HISTORIC LANDMARK COMMISSION
APPLICATION FOR A CERTIFICATE OF APPROPRIATENESS
SEPTEMBER 27, 2021
C14H-2017-0082; HR-2021-084469
MCDONALD-DOUGHTIE HOUSE
1616 NORTHWOOD RD.

PROPOSAL

Replace existing wood fence with stucco estate wall around back yard, construct new black iron fence around front yard, replace sidewalk, and create a landing at the curb.

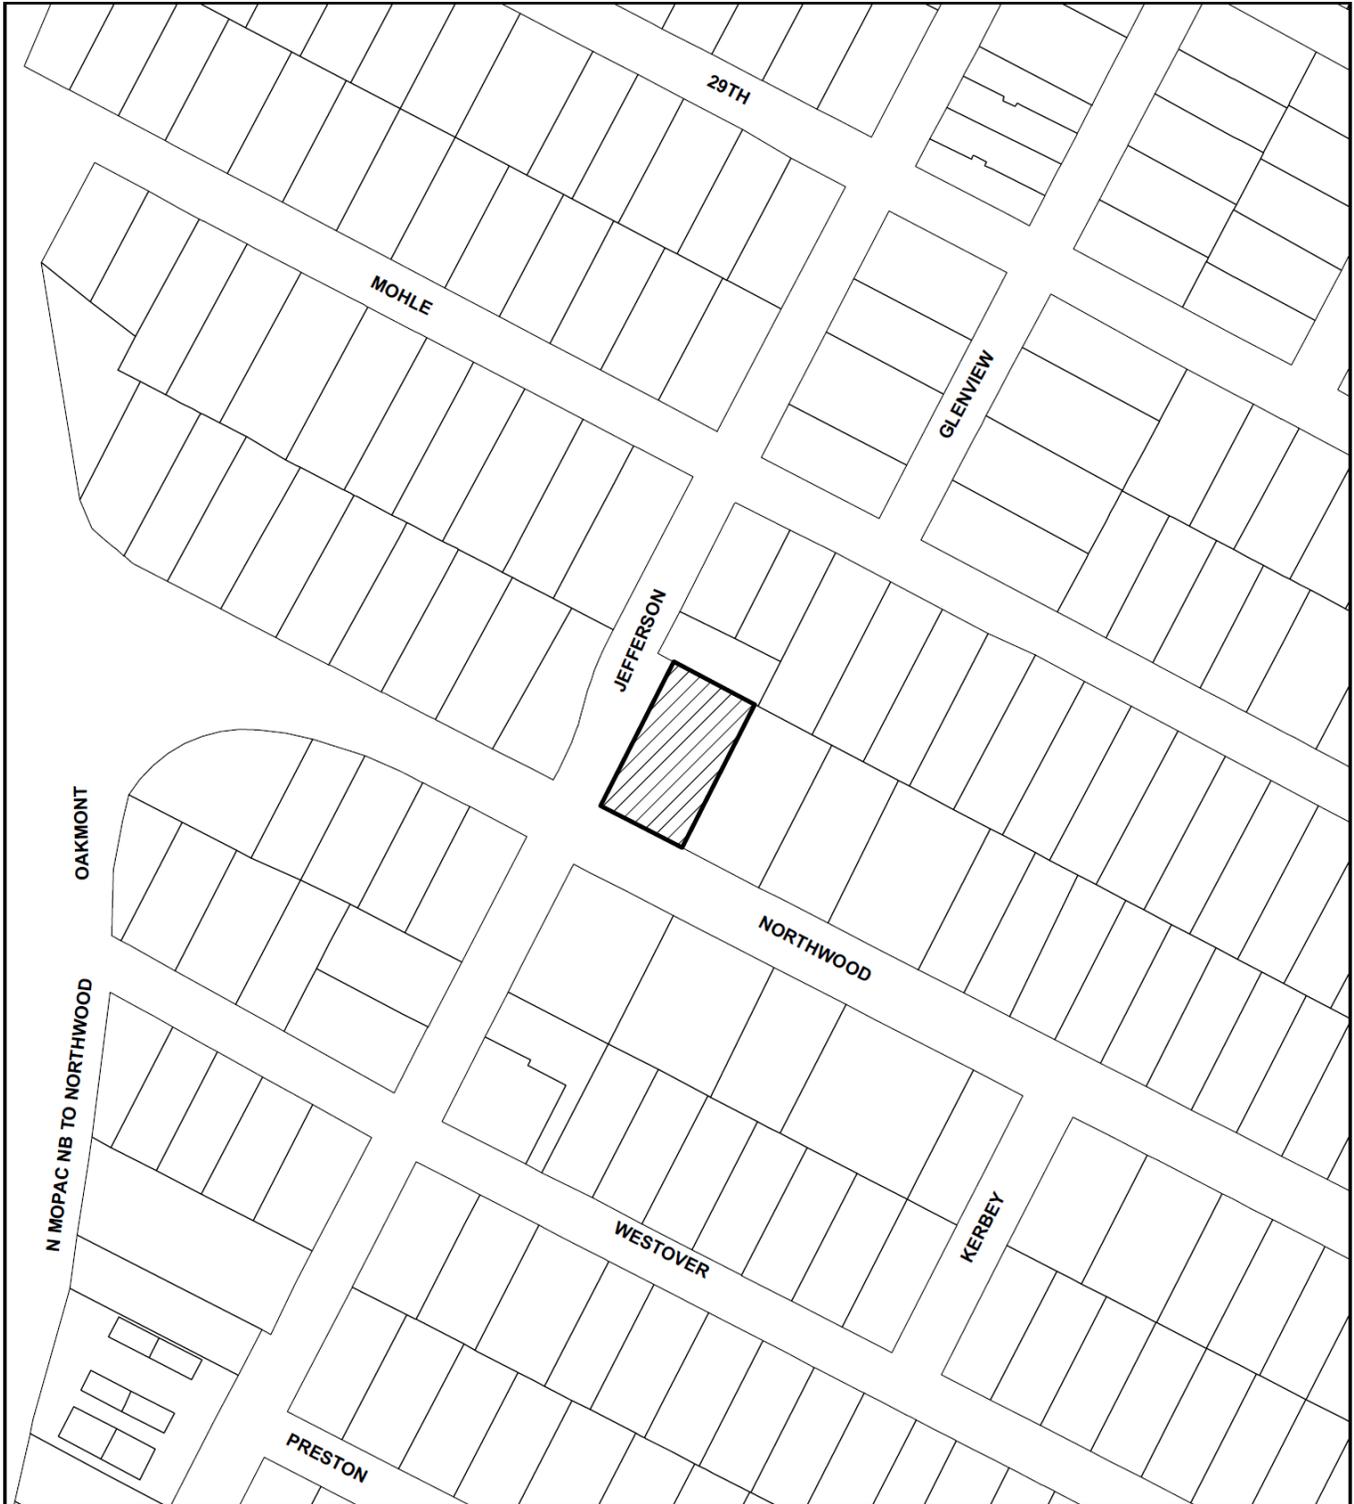
On September 13, 2021, the Architectural Review Committee reviewed a presentation with additional design options under consideration by the applicant. Committee members preferred a stucco or stone retaining wall at the curb landing over a more contemporary option of black metal. Members also recommended a continuous sidewalk rather than stepping stones and discouraged a loose rock border. Members suggested recessing the estate wall from the front corners of the house.

Overall, the committee found that the proposed landscape elements are understated and compatible, and the front fence does not detract from the relationship of the front yard to the home.

The applicant has followed this feedback in making design decisions. The location of the wall is constrained by windows on the side elevations near the front of the house, but the applicant will recess the wall slightly, to the extent practicable.
